Joint Regional Planning Panel Meeting 13 July 2017
548-552 PACIFIC HIGHWAY, ST LEONARDS

Subject: 548-552 Pacific Highway, St Leonards
Record No: DA16/158-01 - 34262/17
Division: Environmental Services Division
Author(s): Diep Hang

Description of the proposal to appear on determination	Demolition of existing commercial premises and construction of a fourteen (14) level Hotel comprising of 194 rooms with basement car parking
Zone	B3 Commercial Core
Is the proposal permissible within the zone	Yes
Is the property a heritage item	No
Is the property within a conservation area	No
Is the property adjacent to bushland	No
BCA Classification	Class 3, 6 and 7a
Stop the Clock used	No
Notification	Neighbours See Notification list on the DA file Ward Councillors – All Councillors Progress Association – St Leonards-Wollstonecraft Residents Association Others - North Sydney Council

Figure 4 – Section (A) showing extent of height variation highlighted in yellow (extracted from Applicant's Clause 4.6 submission of SEE)

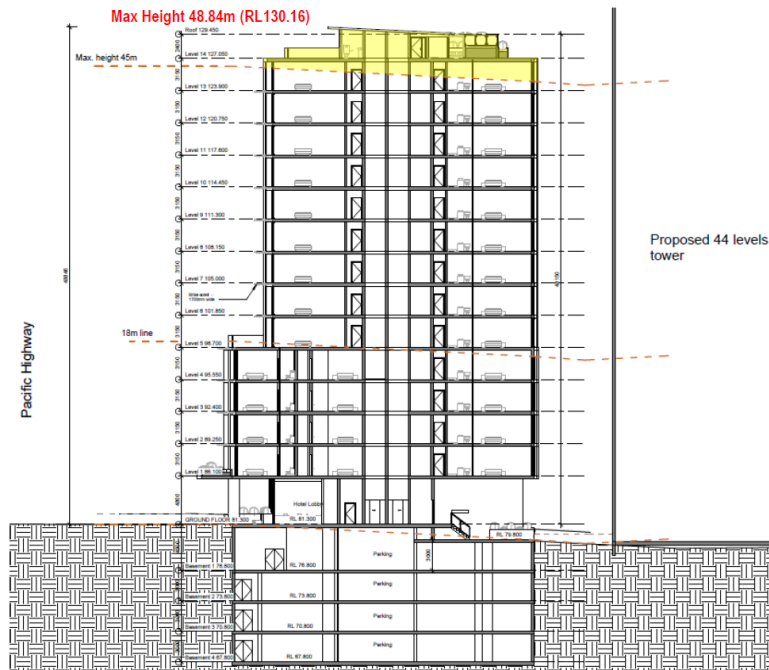
Having regard to the above, it is considered that greater compliance with the development standard is not unreasonable or unnecessary in these circumstances. The departure sought is not considered to be modest and would result in the appearance of additional bulk when viewed from the existing streetscape, as well as provide a segregated interface with the Pacific Highway, which is inconsistent with the built form desired for the St Leonards CBD precinct.

In this regard, it is considered that there are insufficient environmental planning grounds to support variation to the building height standard as the proposal is contrary to both the objectives of the building height development standard and B3 zone, and as such

Figure 7 – Christie Block Plan (Extract from Part D – Commercial Development and Mixed Use Localities of DCP)

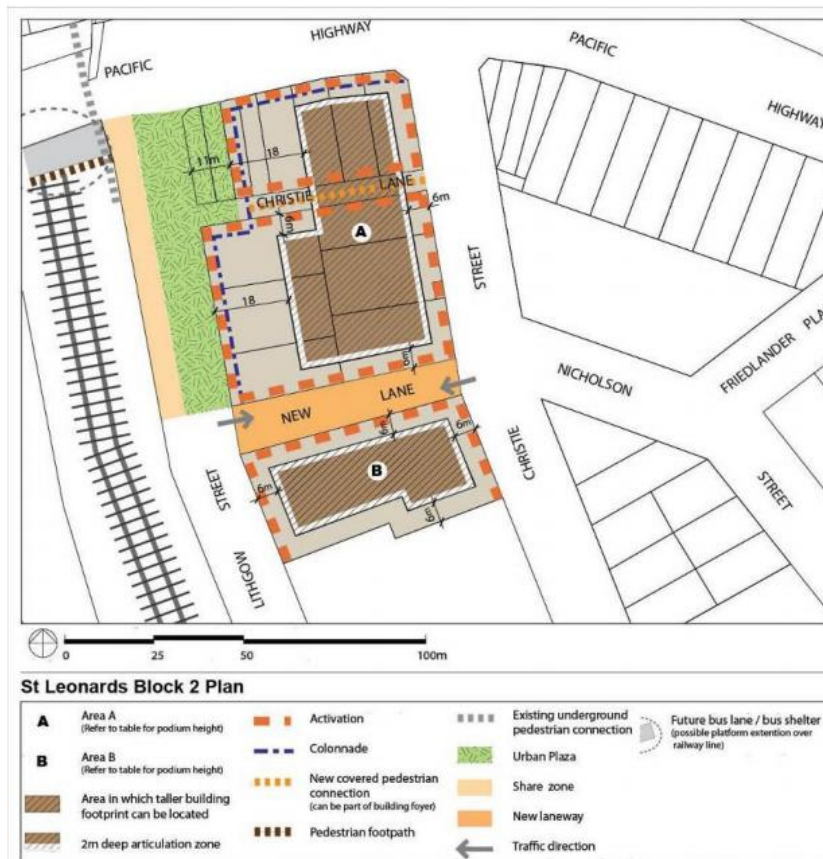
4.3 Built Form	Proposal	Comment
<p>a) New development on the southern side of Pacific Highway across the St Leonards Station is to comply with the block diagrams provided.</p> <p>b) The development for major blocks is to be a tower and podium form to mitigate against wind impacts and achieve a human scale at the street.</p> <p>c) Blocks located at 'gateway' corners as indicated in the block plans are not required to provide podium bases but should respect the alignment of the adjoining podiums in the design of the architecture. These towers are to create an entry</p>	<p>The subject site forms part of a major block plan within the Christie Precinct.</p> <p>The building is one built form and does not incorporate towers.</p>	<p>The objectives and development controls (i.e. access, setbacks, activation etc) for the precinct recognised that the subject site is to be developed together with adjoining properties, particularly in order to provide sufficient yield to the amalgamated sites in order to permit a significant open space area for the eastern portion of the proposed Rail Plaza.</p> <p>The development of the subject site for use as a hotel although permissible, is fragmented and small scale which is contrary to the Christie Precinct block plans with respect to the envisaged built</p>

In relation to the Christie precinct, the DCP block plan provides and highlights the intended planning outcome for the precinct which requires amalgamation of sites. Although the proposed building footprints of some of the sites may change, the DCP provisions have consistently envisioned:

- A new vehicle entry point for "Area A" to be provided off Christie Street;
- Christie Lane to be closed to vehicular traffic in order to "*provide new pedestrian mid-block link generally in the existing location of Christie Lane*"; and
- Relocation of Christie Lane to the south, adjacent to No. 80 during redevelopment.
